Technical Review Form: Designate SR 686/ 118th Ave Connector as a Planned SIS Highway Corridor
(a letter, email or fax with the same information is acceptable)

Reviewer: Terry Kraft District(s): 7 District Coordinator(s): Waddah Farah; Peter Maass

**SR 686/118th Avenue
C&E Review - Community**

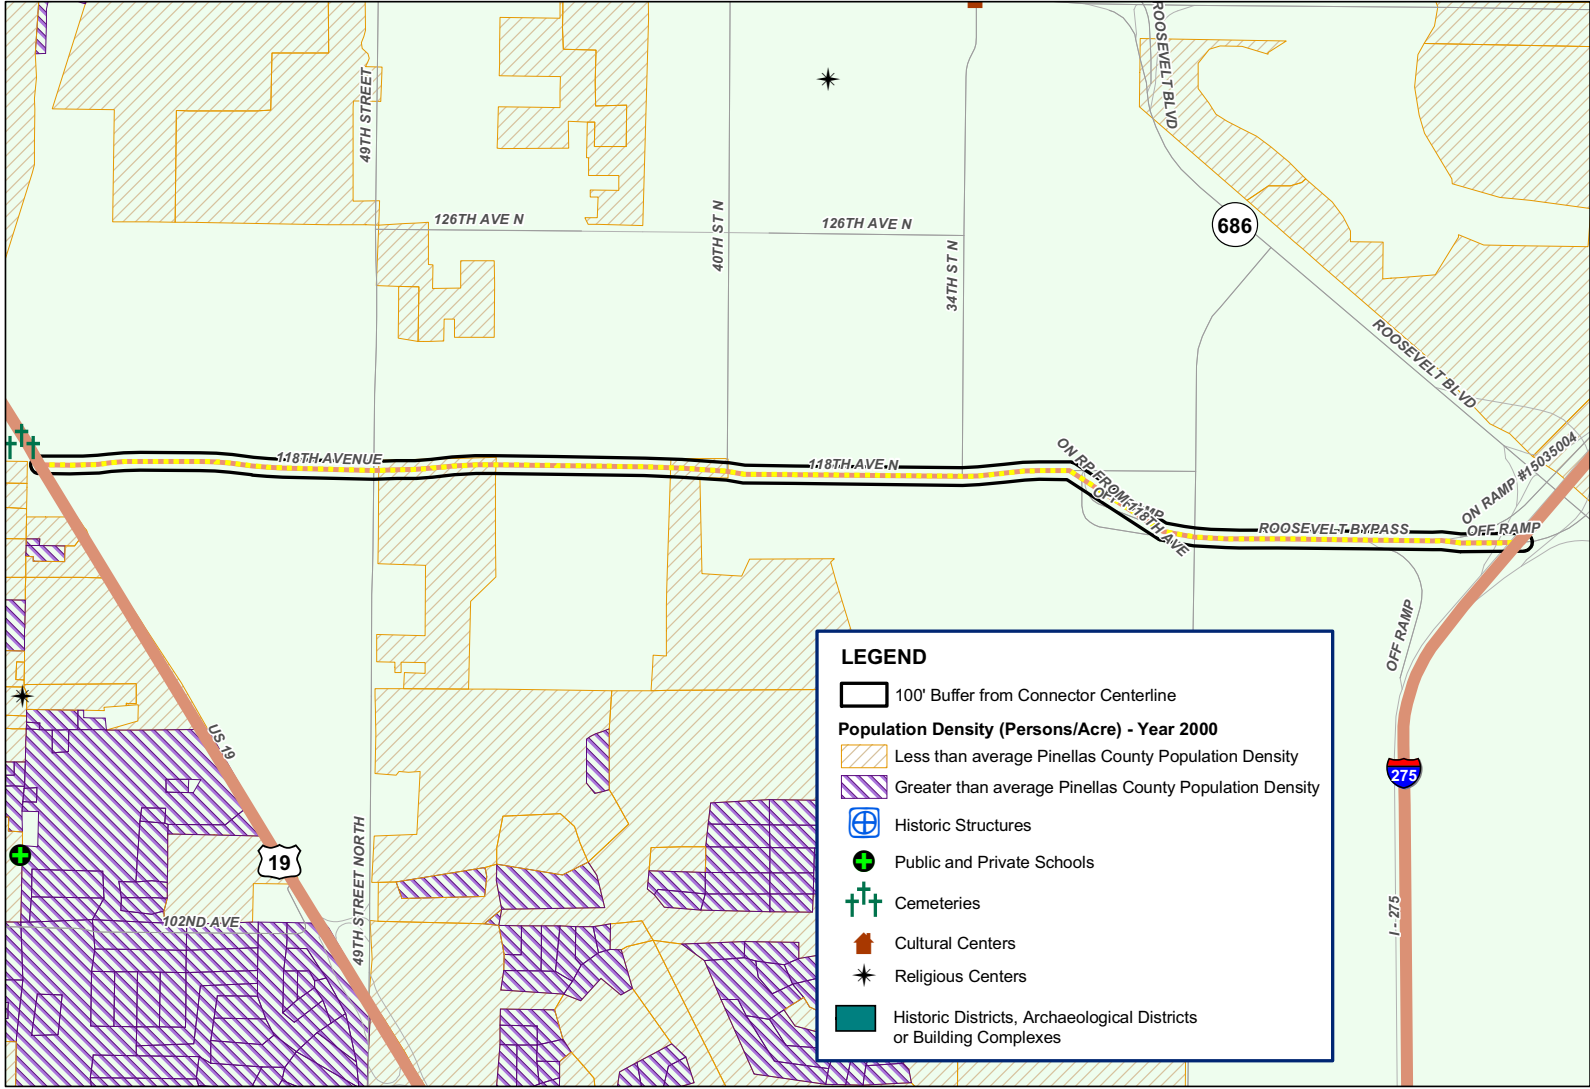
Community and Environmental Screening Criteria (see the "Adopted Criteria and Thresholds" part of the Strategic Intermodal System Atlas)	Meets All Criteria Y/N/DK/NA ¹	Comments
<i>Community Livability - Character & Function</i>	Y	FDOT performed a high-level screening of community and environmental features and there does not appear to be any significant conflicts in the area surrounding the proposed corridor. The attachment maps show the location of community and environmental features surrounding the proposed corridor. A more detailed community and environment screening has occurred as part of project development and environmental studies.
<i>Community Livability - Land Use</i>	Y	
<i>Environmental Quality - Air Quality</i>	Y	
<i>Environmental Quality - Natural Resource Lands, Cultural and Historical Sites, Agricultural Areas</i>	Y

Community and Environmental Screening Criteria (see the “Adopted Criteria and Thresholds” part of the Strategic Intermodal System Atlas)	Meets All Criteria Y/N/DK/NA ¹	Comments
		<p>some segments may fall below. Traffic volumes have not been modeled for the year of opening but it reasonable can be assumed that the majority of the corridor will meet the level of service standards at that time. As traffic grows over time, additional investments may be needed to ensure that level of service does not deteriorate.</p> <p>FDOT reviewed the comprehensive plans of the local jurisdictions. While the local jurisdictions have various development projects along this corridor, there is nothing in their comprehensive plans that would preclude this corridor from functioning as a SIS corridor.</p>
